ADJUSTING OIL VALVE BOX "A"

TERRITORIAL HIGHWAY DEPARTMENT
TERRITORY OF HAWAII
ADJUSTING OIL AND WATER VALVE BOXES
HONOLULU PEARL HARBOR RD. SNAF 44-(4)
March, 1947

ADJUSTING OIL VALVE BOX "B"

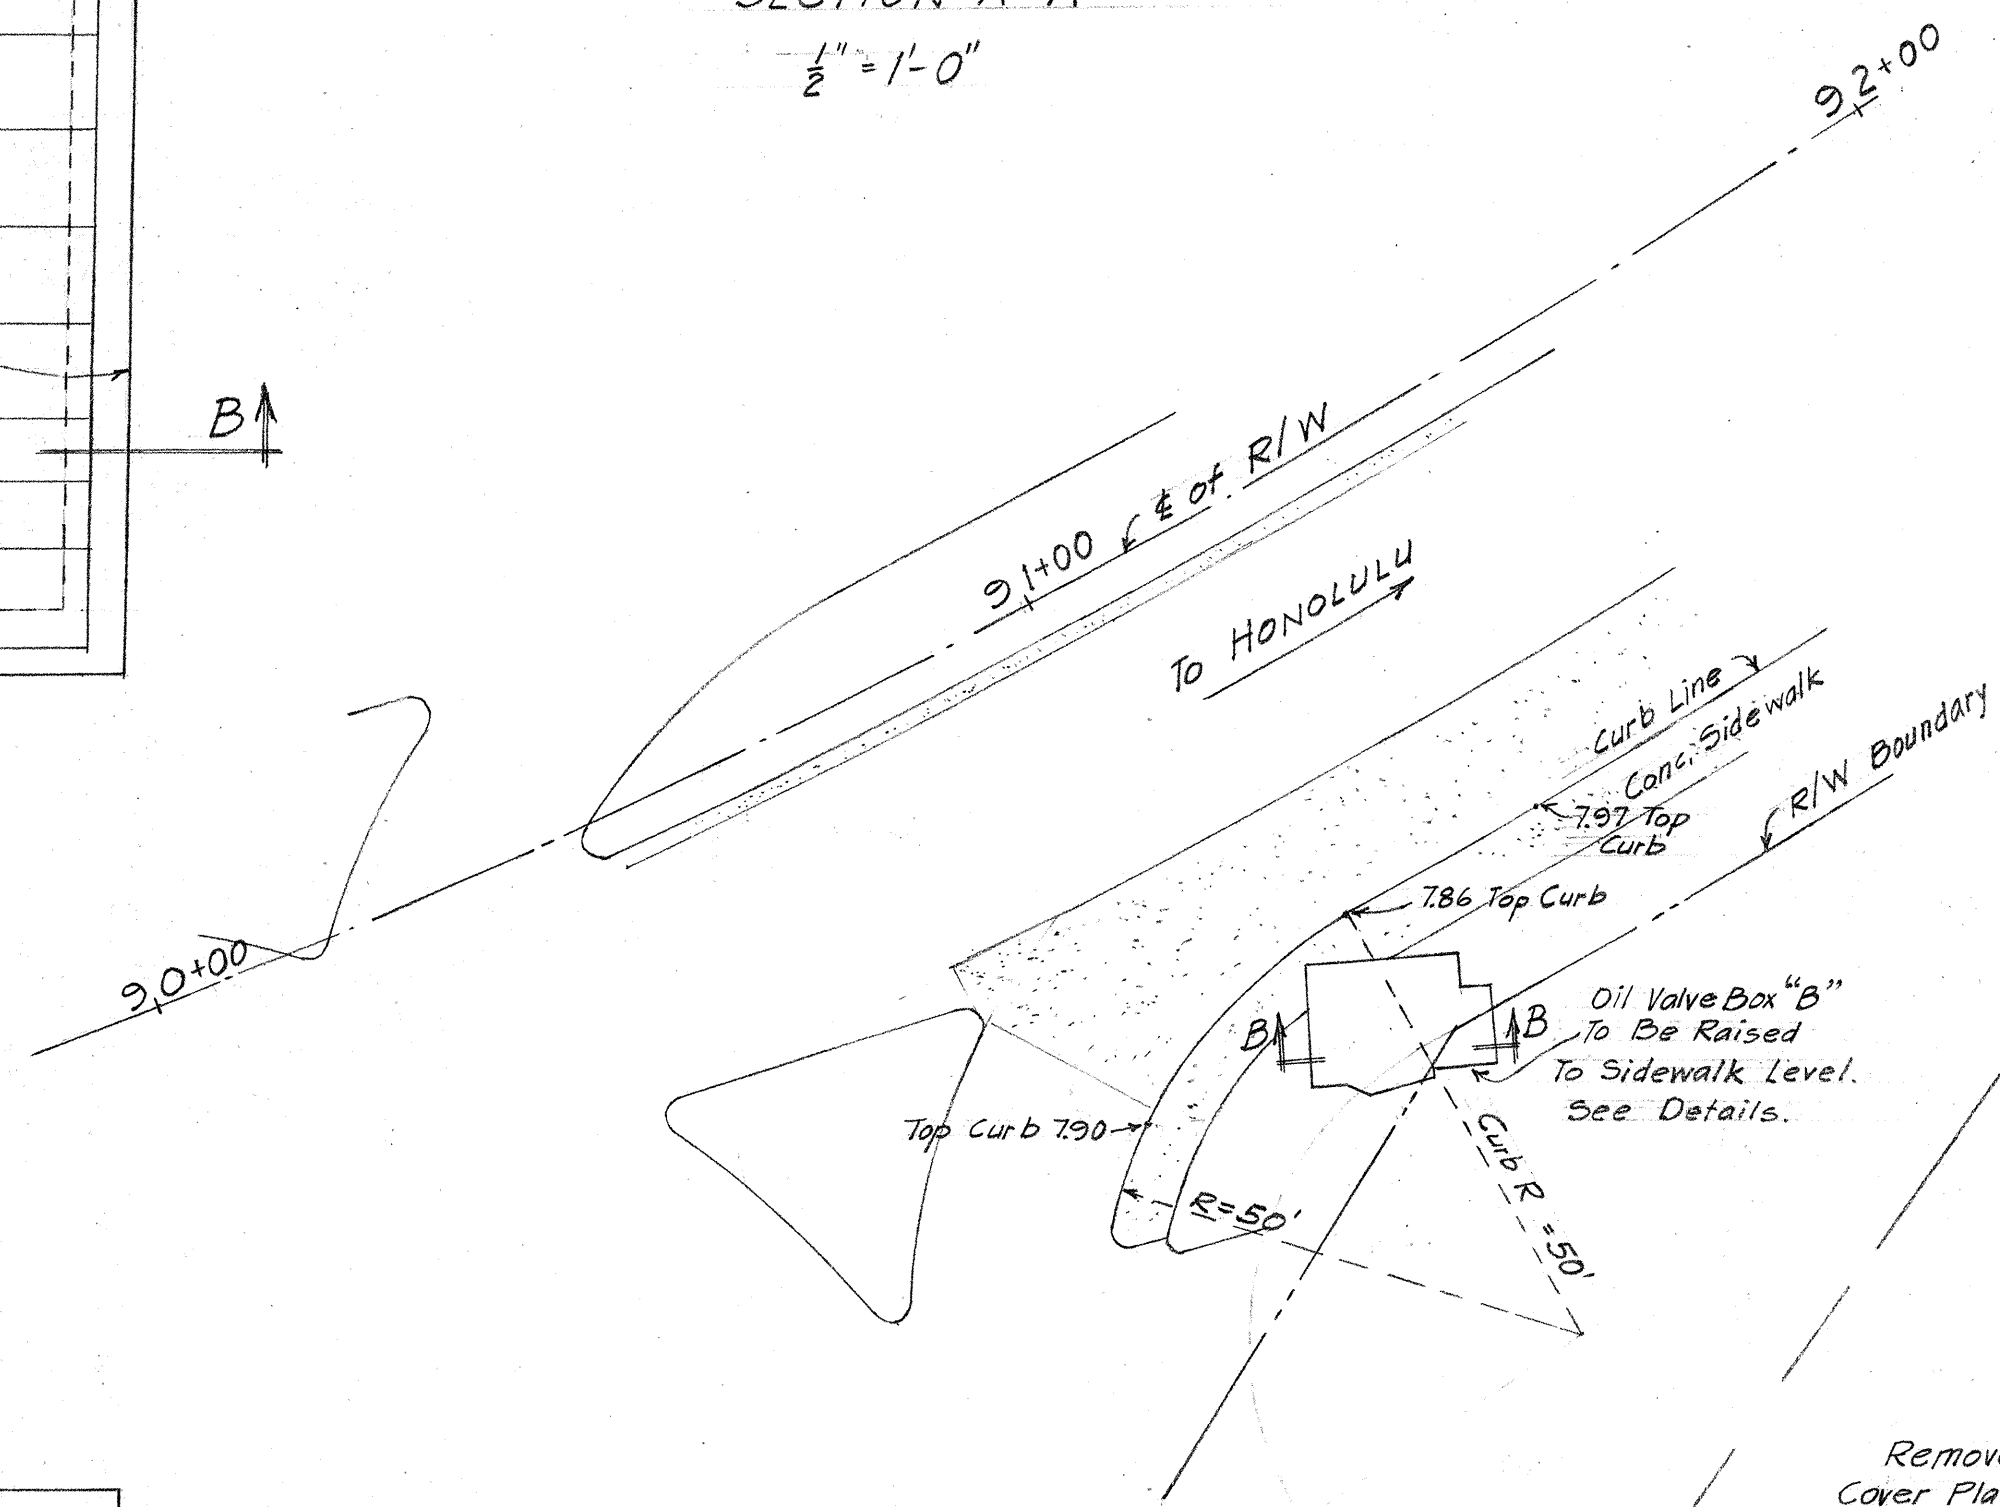
NOT IN CONTRACT

Correction 11-18-47

NOTE! ADJUSTING OIL VALVE BOX "B" IS NOT PART OF CONTRACT.
